## SYDNEY NORTH PLANNING PANEL

<b>JRPP No</b>	2016SYW046
<b>DA Number</b>	DA/1676/2015
<b>Local Government Area</b>	Hornsby
<b>Proposed Development</b>	Demolition of community centre and child care centre and construction of two x five storey residential flat buildings containing 92 units above basement car parking
<b>Street Address</b>	Nos. 18 – 22 Lords Avenue and Nos. 421-425 Pacific Highway, Asquith  Lot 27 DP 12901, Lot 28 DP 12901, Lot 29 DP 12901, Lot 3 DP 136220, Lot 13 DP 653870, Lot 2 DP 136220
<b>Applicant/Owner</b>	Northern Group Pty Ltd
<b>Number of Submissions</b>	Two
<b>Regional Development Criteria (Schedule 4A of the Act)</b>	CIV>\$5 Million  Cost (estimate): \$19,679,674  The site was previously owned by Council
<b>List of All Relevant s79C(1)(a) Matters</b>	<ul style="list-style-type: none"> <li>• Hornsby Local Environmental Plan 2013 (HLEP)</li> <li>• Hornsby Development Control Plan 2013 (HDCP)</li> <li>• Hornsby Shire Council Section 94 Development Contributions Plan 2014-2024</li> <li>• State Environmental Planning Policy No. 55 – Remediation of Land (SEPP 55)</li> <li>• State Environmental Planning Policy No. 65 – Design Quality of Residential Apartment Dev

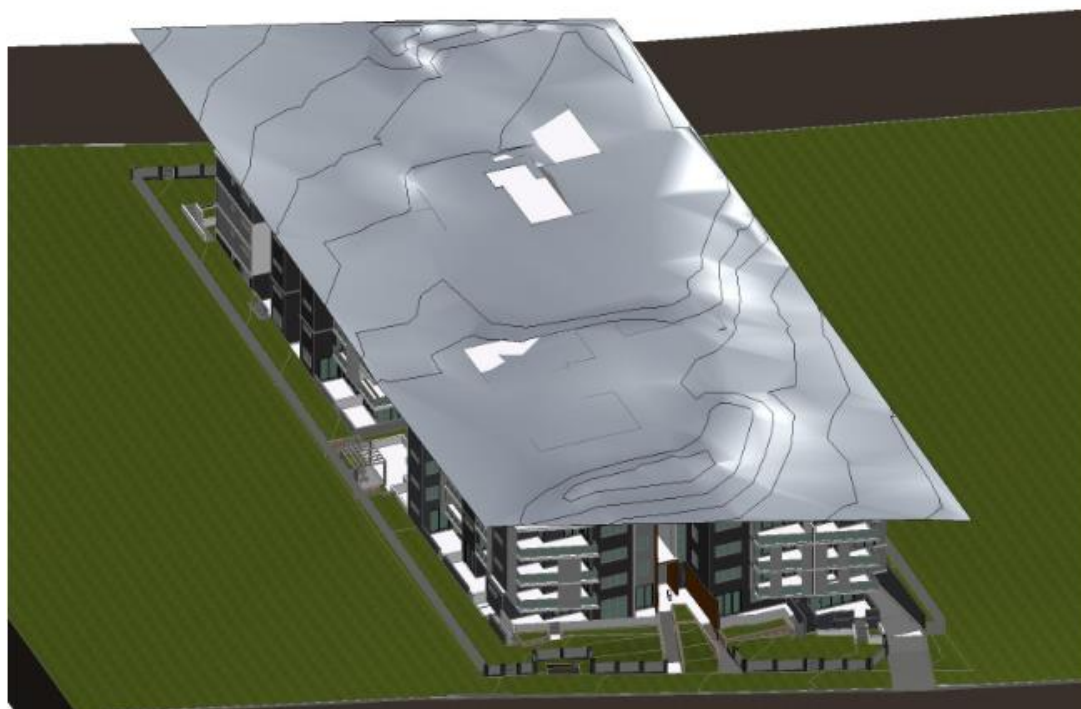
Clause 4.3 of the *HLEP* provides that the height of a building on any land should not exceed the maximum height shown for the land on the Height of Buildings Map. The maximum permissible height for the subject site is 17.5m. The proposal has a maximum height of 17.95m and does not comply with this provision as discussed below.

1 Section 5  
Scale 1:150 @ A1  
Scale 1:300 @ A3

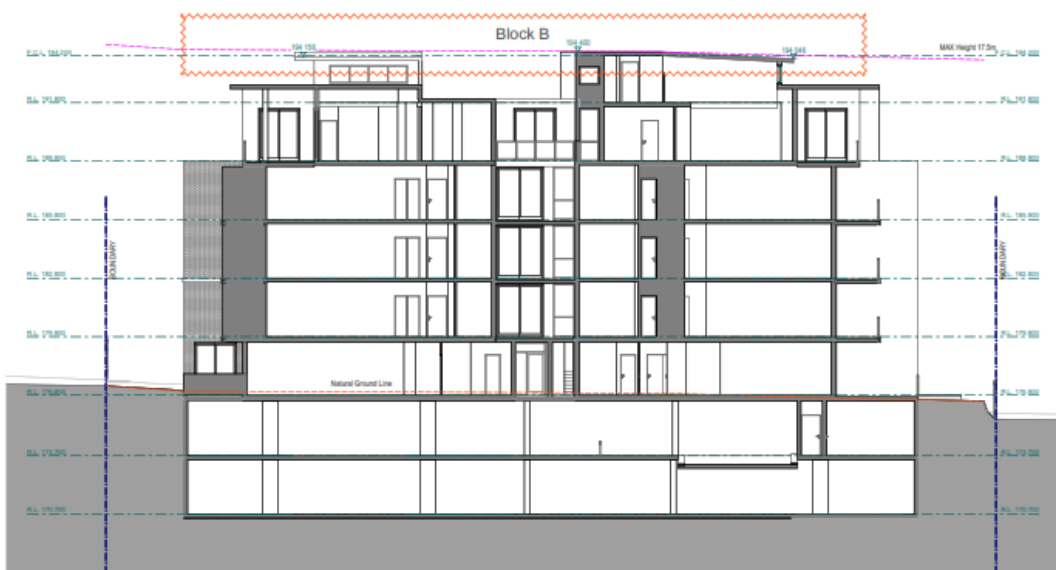
The height of a building is defined under *HLEP* as from existing ground level to the uppermost point of the building. The site has been the subject to previous earthworks in order to construct the existing community centre, childcare buildings and associated landscaping. As a result of the prior site works, the levels centrally within the site do not directly reflect the natural ground levels which exist on the boundaries of the site. The applicant has prepared a 3D height plane to illustrate the extent of the non-compliance. The analysis of the height variation as submitted by the applicant does not accurately indicate the extent of the variation sought. The applicant states the extent of the variation as 170mm above the 17.5m height limit, in the areas highlighted white.

To achieve greater compliance with the height limit, the plans have been amended to provide for a raked and stepped roof forms to reduce the maximum height variations of up to 450mm as indicated in the extracted Sections below to 170mm as calculated by the applicant.

Additionally, the height plane as presented by the applicant does not indicate the existing levels of the land, but instead adopts the floor levels of the existing buildings from which the height is calculated. Where the floor levels of the existing buildings have been adopted as
